## Development Services Staff Report

<b>File Number</b>	PL2025-052
<b>File Name</b>	Preliminary Development Plan – TODCO Beverages
<b>Applicant</b>	Engineering Solutions
<b>Property Address</b>	1270 SE Century Dr.
<b>Planning Commission Date</b>	July 10, 2025
<b>Heard by</b>	Planning Commission and City Council
<b>Analyst</b>	Claire Byers, Senior Planner

Figure 4 – Architectural Elevations

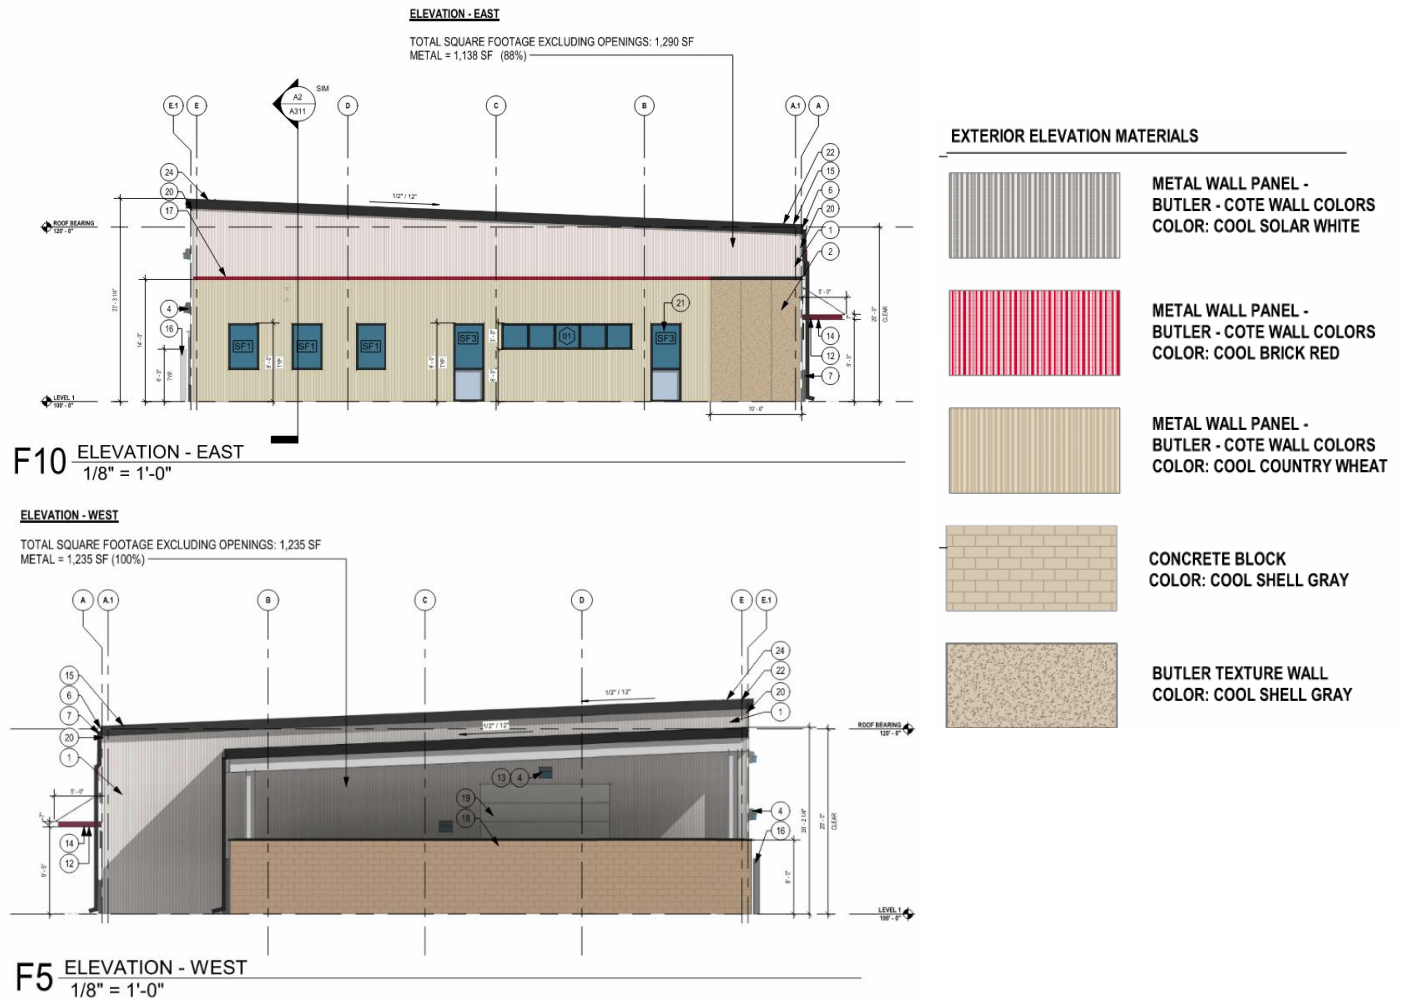
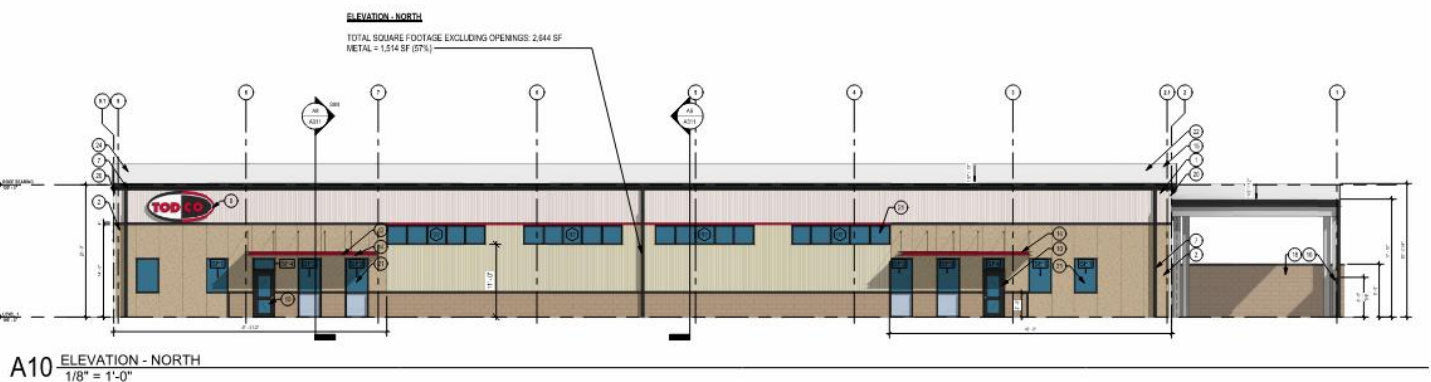
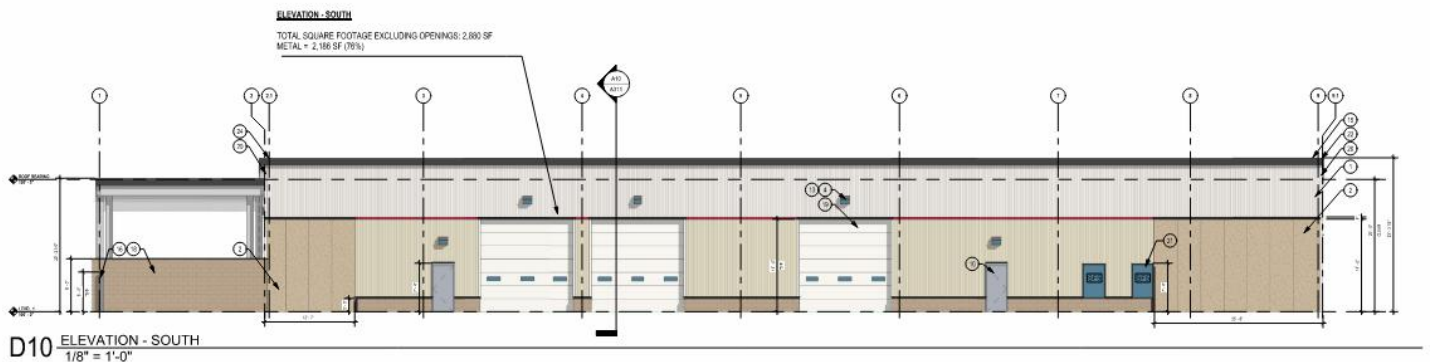
1. The applicant is seeking a modification to UDO Section 8.170 pertaining to the permitted building materials for industrial buildings. Staff has reviewed the request and supports the modification for the reasons identified below.

- **Required-** Metal may not exceed 40% of any façade. A modification for the use of metal up to 75% of any façade may be approved by the Planning Commission. A modification for the use of metal to exceed 75% of any façade may be approved by the Governing Body.

- **Proposed-** The applicant has proposed exterior elevations that exceed the 40% maximum usage of metal allowable by right.
  - North elevation- 57% metal proposed

- East elevation- 88% metal proposed
  - South elevation- 76% metal proposed
  - West elevation- 100% metal proposed
- **Recommendation-** The subject property was previously within the Metal-Building Overlay, which would have allowed the proposed metal façade as shown without requiring a Preliminary Development Plan modification request. In contrast, neighboring industrial buildings were developed with minimal architectural requirements, such as metal panel systems with only one color, and no architectural variations. Additionally, the proposed building is oriented towards the north of the site near the private drive, instead of along the SE Bailey Dr. frontage. The view from the ROW would be primarily of landscaping as well as a 6' tall privacy fence to provide a visual buffer from the rear accessory outdoor storage.

1. A modification shall be granted to the maximum allowable 40% use of metal on any façade, to allow the following percentages of metal on the respective facades: 57% on the north elevation; 88% on the east elevation; 76% on the south elevation; and 100% on the west elevation.
2. The development shall occur in accordance with the Preliminary Development Plan dated June 13, 2025.
